DATE: 11.15.2017

■ **MARSH POINT SUBDIVISION [TRC Plan Review]**

∞ Initial Review Note ∞

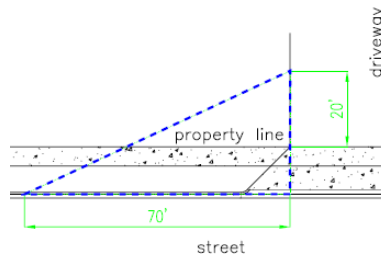
- Revise all sheets to accurately illustrate the existing conditions on and surrounding this parcel. Show all adjacent traffic signs, lane configurations, traffic control devices and pavement markings, for the intersection of Wrightsville Ave and Rogersville Rd, on the site inventory plan. Please refer to the Technical Standards and Specifications Manual (link is below) Ch. VII C.1.a.2. for specific information and distance requirements. Contact Traffic Engineering at 341-7888 if you need assistance locating these elements.
